RHODE ISLAND DEPARTMENT OF TRANSPORTATION

Bridge Group 54A -Kingston Rd Bridge

NOTICE TO PROSPECTIVE BIDDERS

ADDENDUM NO. 1 Prospective bidders and all concerned are hereby notified of the following changes in the Plans, Specifications, Proposal and Distribution of Quantities for this contract. These changes shall be incorporated in the Plans, Specifications, Proposal and Distribution of Quantities, and shall become an integral part of the Contract Documents.

END DIAPHRAGM (D-1)
SCALE: 1"=1'-0"

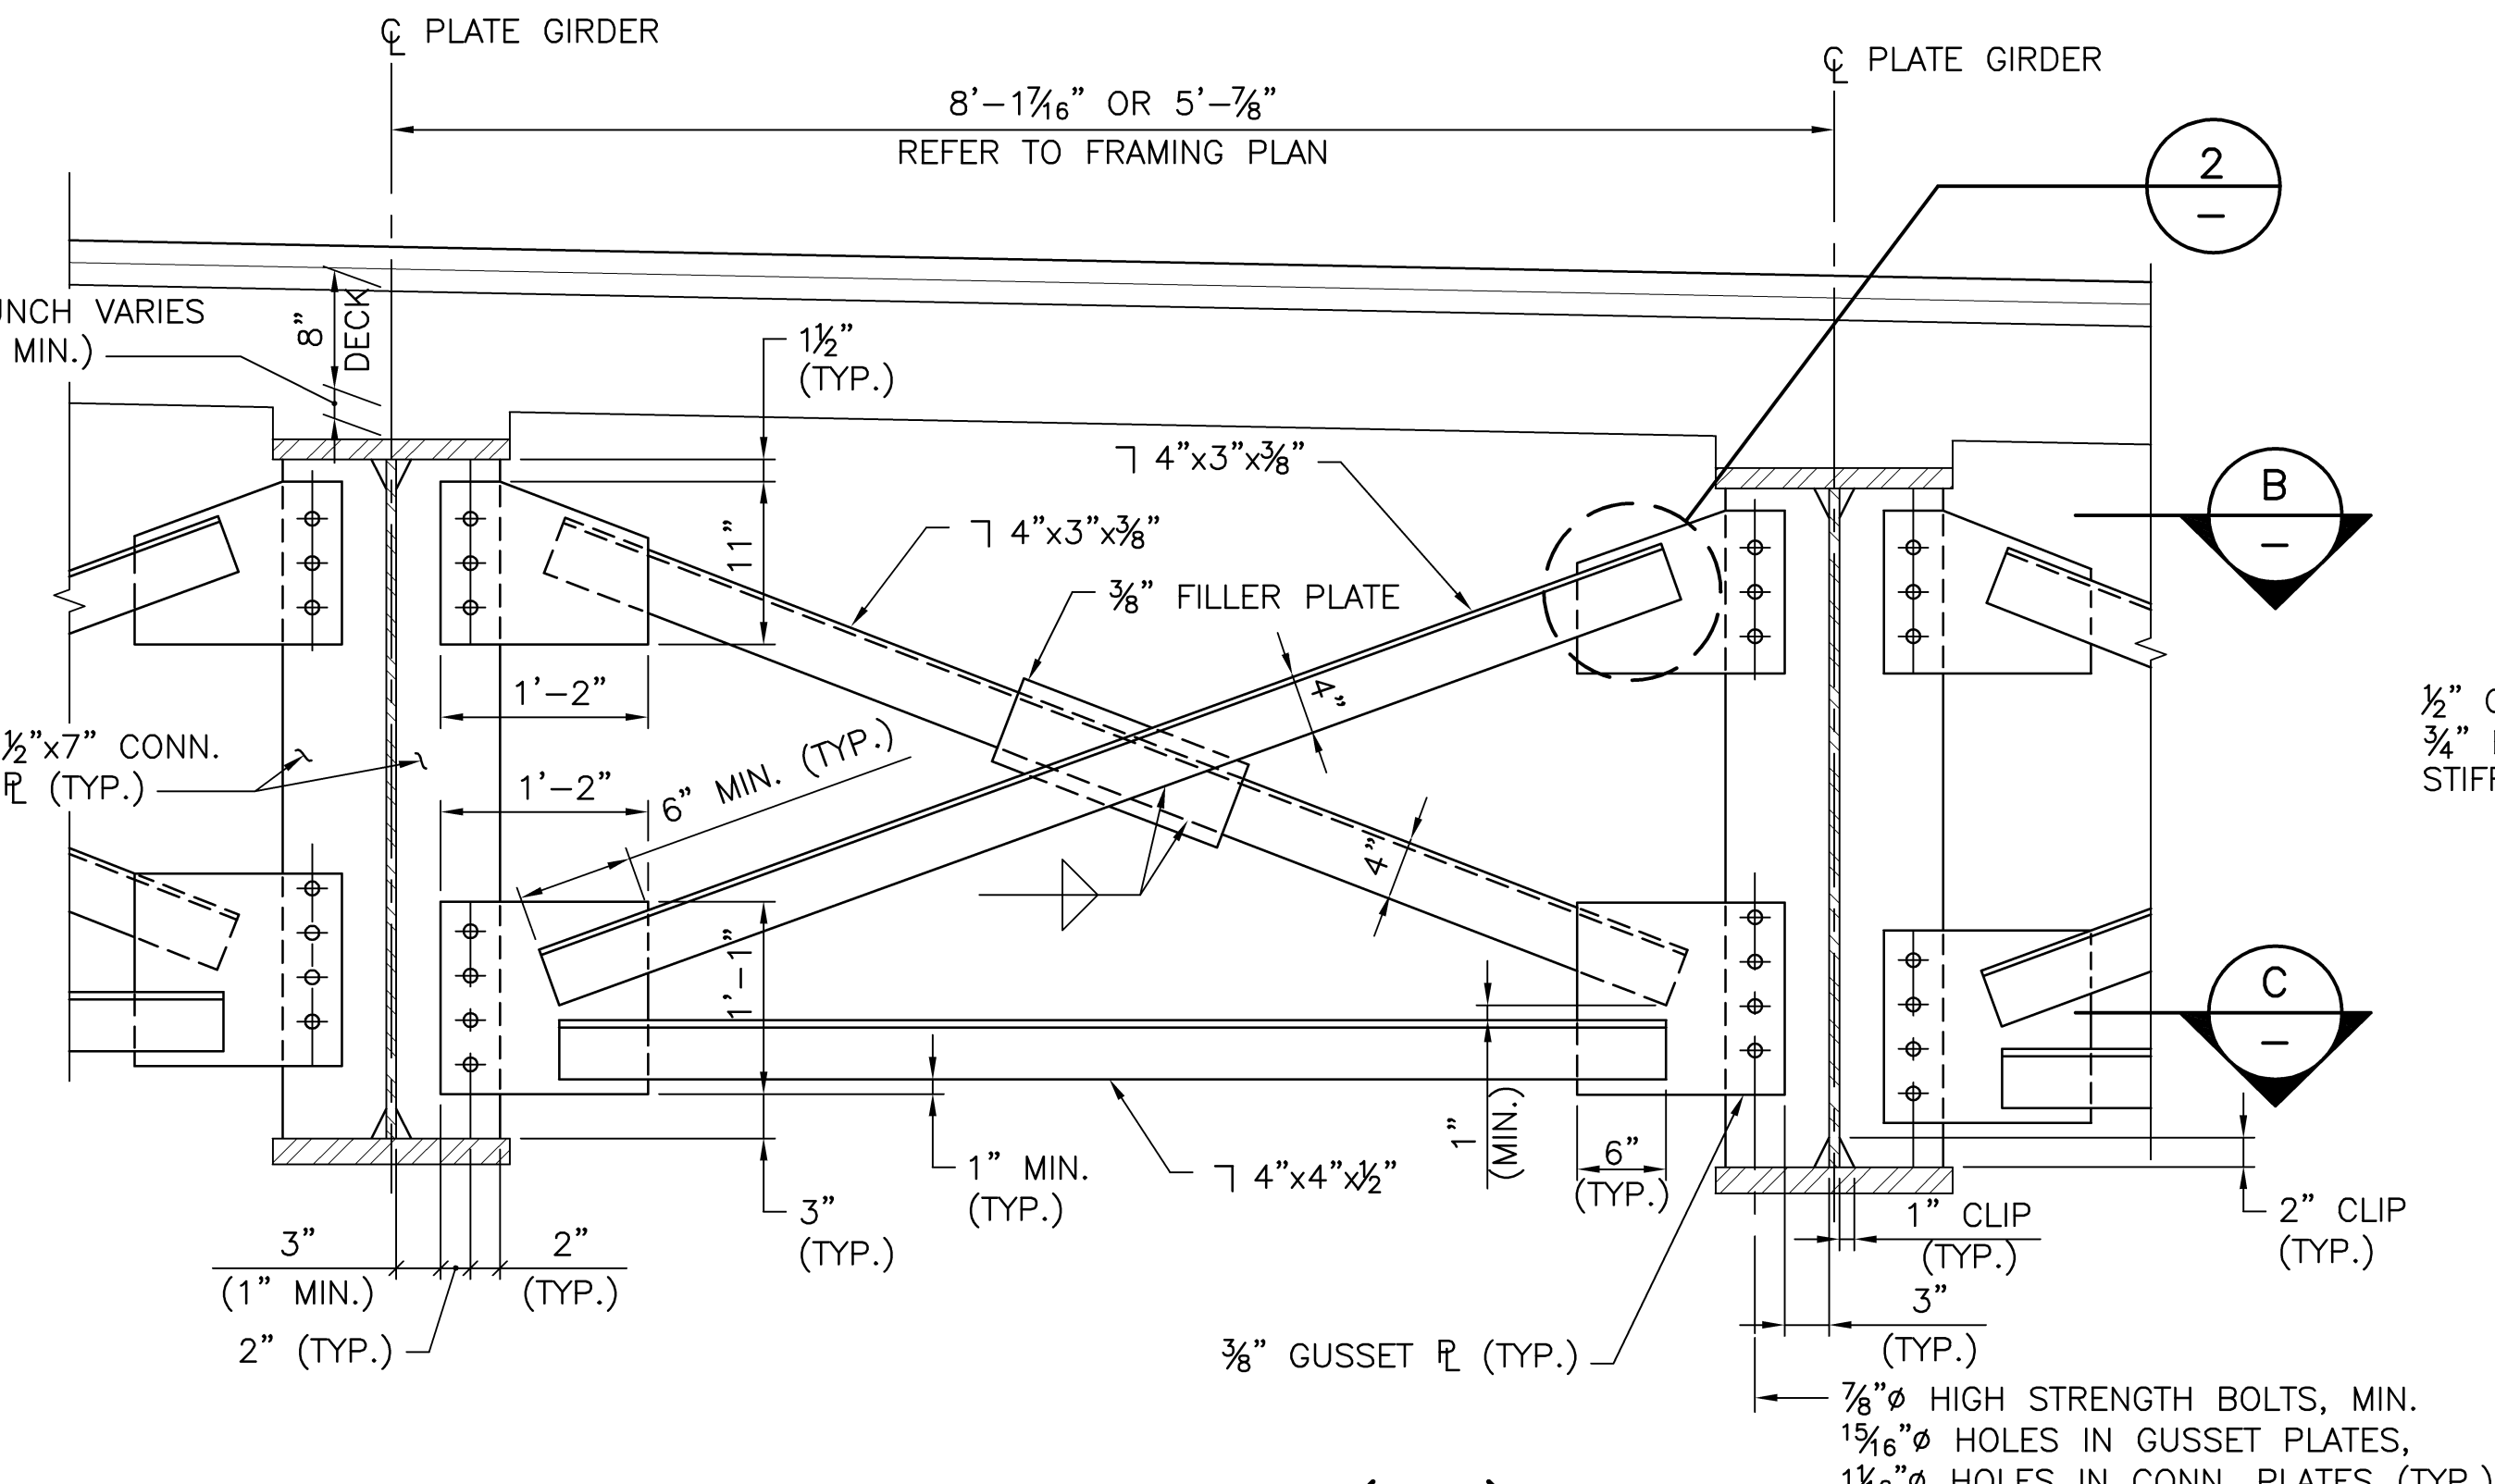
In clarification of the previous question, is it intended that the diaphragm stiffeners have a 5/8" weld or is a 5/16" sufficient?

Ref: Sheet 29 of 41, End Diaphragm (D-1) Detail: Shows a 5/8 (TYP) inch fillet weld for "3/4" X 5" bearing stiffeners" which appears to be an error since these stiffeners are attached to the diaphragm. Although, Section A on this sheet shows a "3/4" X 7" End Bearing Stiffener" with a 5/16 weld. Please confirm which is correct.

The weld will be revised to 5/16" by Addendum.

The 5" X 5" bearing stiffeners are welded to the webs of the end diaphragm. Section A shows the connection of the end diaphragms to the Girder with 3/4" X 7" connection plates; these are also the end bearing stiffeners of the Girder. All welds are 5/16. The detail will be corrected by Addendum.
